Subject: Catawba Brochure Revision

Attached please find a first draft copy of the Catawba brochure. The form it is provided in here will change to a brochure version when put into a final draft, but for now this is a more expedient method for review. This brochure is different from that used at Oconee and McGuire to date, and is an attempt to lower the reading grade level as well as to include all NRC/FEMA required information. We intend to incorporate similar changes to the Oconee and McGuire brochures based on our experience with Catawba.

CATAWBA NUCLEAR STATION
Emergency Brochure
(Inside Flap - Front Page)

**Cetawba
Nuclear Station**
1083 Edition

#1

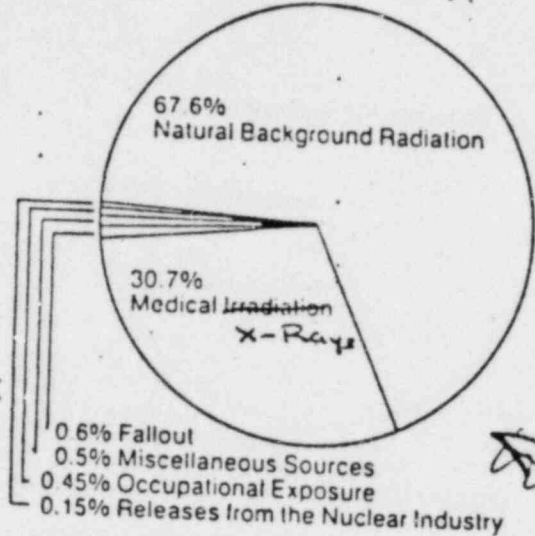
What is the amount of other medical X-Rays?

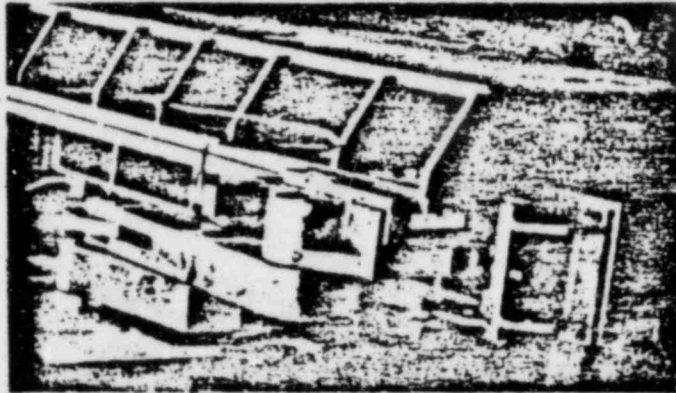
"Or" should be "on" on map

pg. 12 change "response" to "operations" ✓
pg. map listing - change "161" to "160" ✓
